Project: Nunapitchuk Construction

Solicitation No.: 22012

Addendum No. One

BULK FUEL UPGRADES
 SURVEY CONTROL
 NUNAPITCHUK, ALASKA

3 SURVEY CONTROL
 SCALE: GRAPHIC

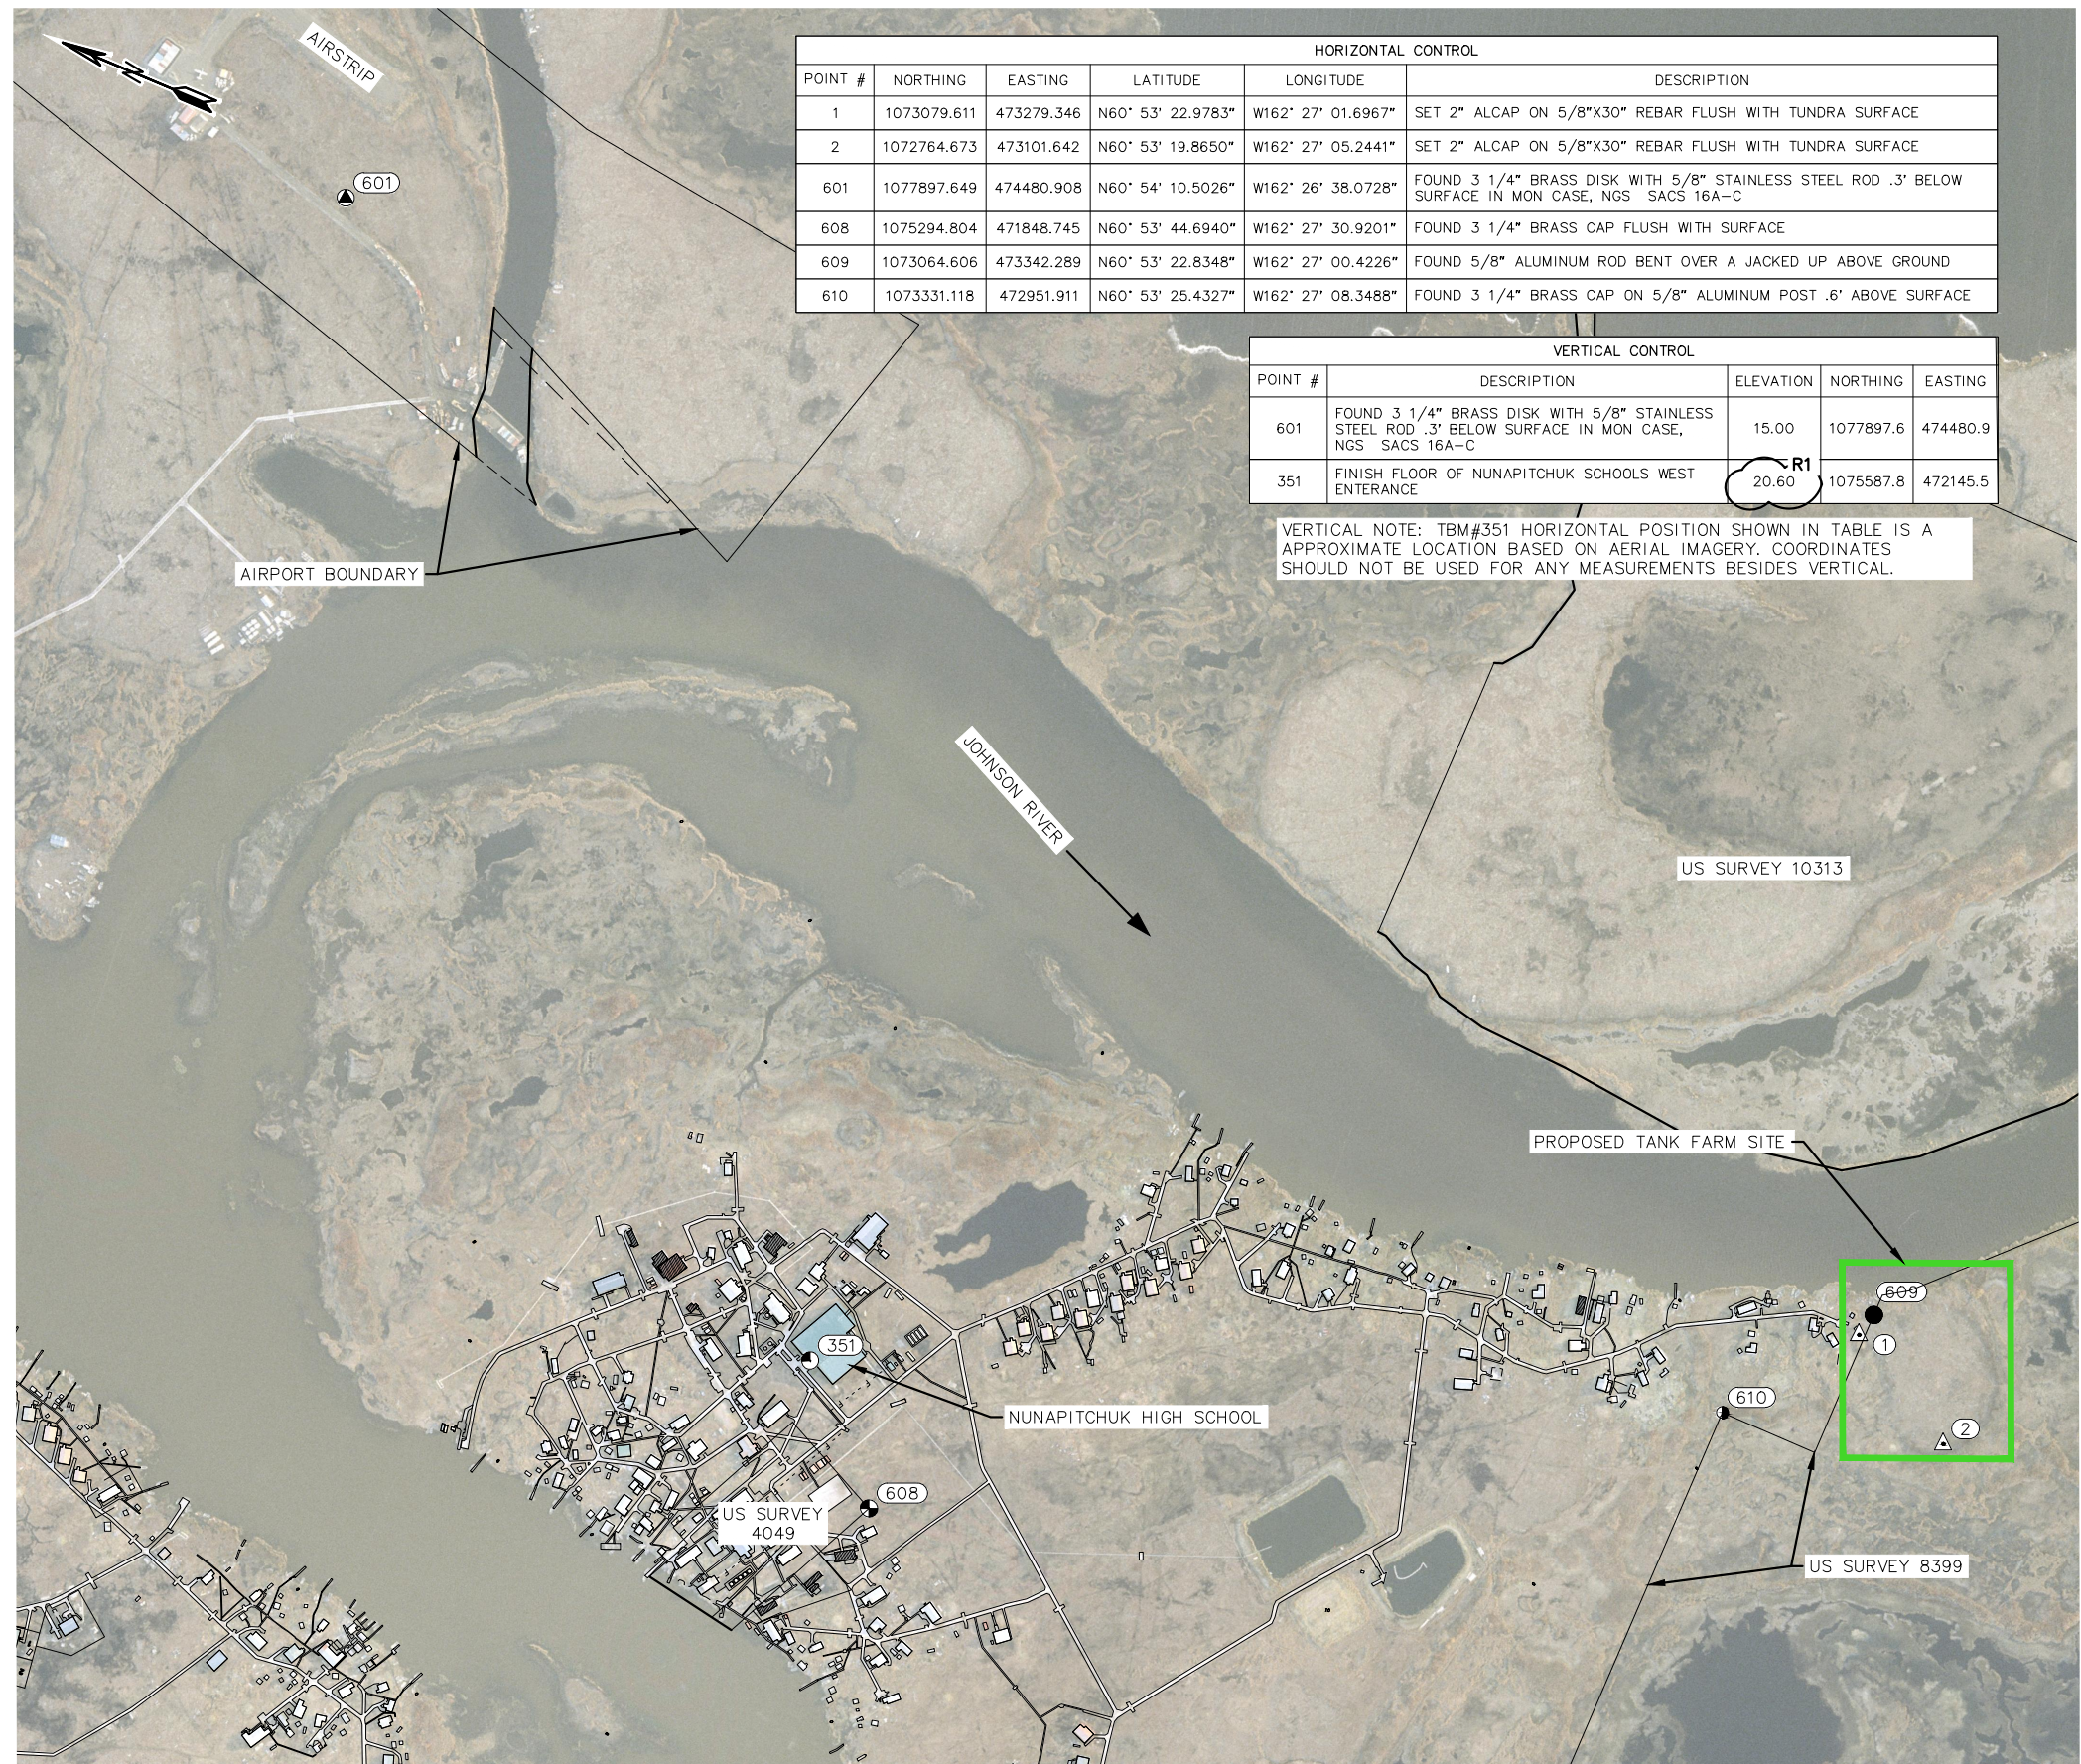
Item #4- Design Drawing Revision: Replace Sheet G3 SURVEY CONTROL with Sheet G3 SURVEY CONTROL attached to this addendum. See clouded revisions on Sheet G3 for minor changes.

Question: Is the contractor required to provide a survey?

Answer: *The Design Drawing Sheet G3 provides horizontal and vertical survey control for the project. All other survey work is the responsibility of the Contractor.*
